REMARKS

Application No. 10/694,630
Paper Dated: May 15, 2006
In Reply to USPTO Correspondence of February 16, 2006
Attorney Docket No. 964-031639

AMENDMENTS TO THE DRAWINGS

FIG. 1b

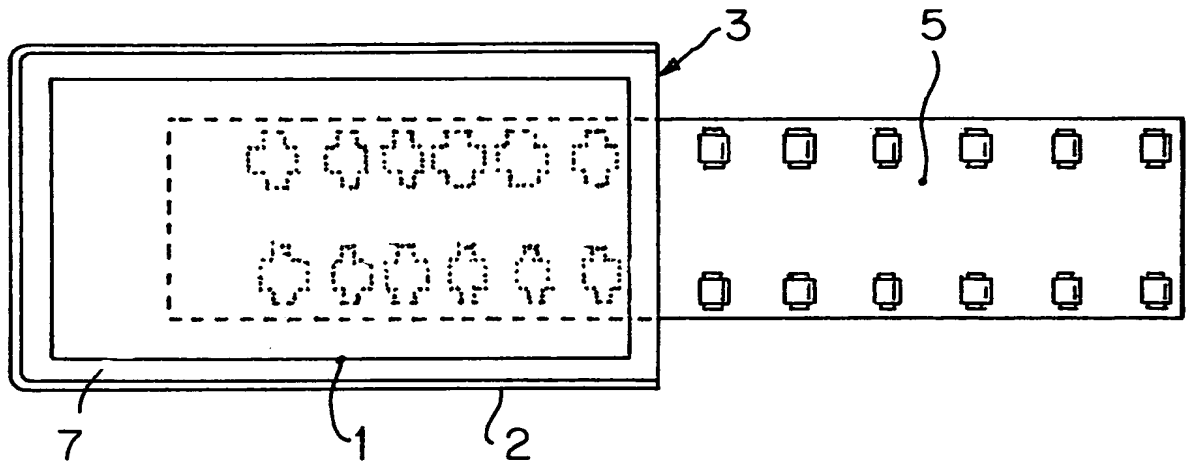
On page 2 of the Office Action, the Examiner required drawing corrections to Figs. 1b, 2b, 3b, and 4b to place these figures in conformance with conventional drawing rules. Applicants enclose herewith drawing sheets showing proposed drawing corrections to Figs. 1b, 2b, 3b, and 4b in red ink as suggested by the Examiner to correct the drawing figures.

Applicants include herewith drawing sheets showing proposed drawing corrections in red ink to Figs. 1b, 2b, 3b, and 4b. Approval of the proposed drawing corrections is respectfully requested.

FIG. 4b

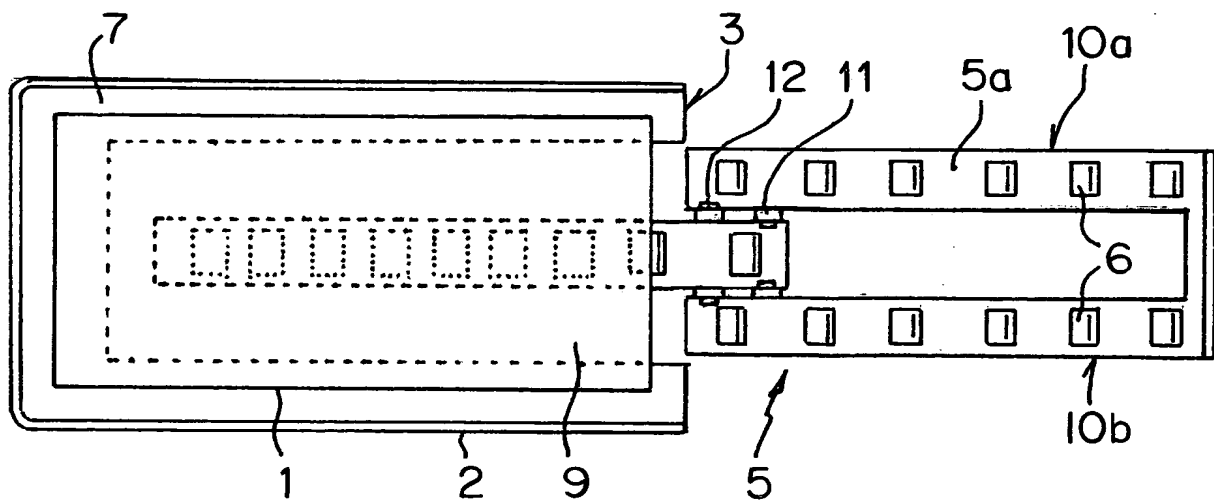
accordance with paragraphs 0035-0037 of the specification to specifically disclose the conveyor structure shown in Fig. 4b of the pending application. Therefore, Applicants will discuss the patentability of amended claim 1 over the Jarl and Driggers combination. The other rejections are believed moot in view of the amendments to claim 1.
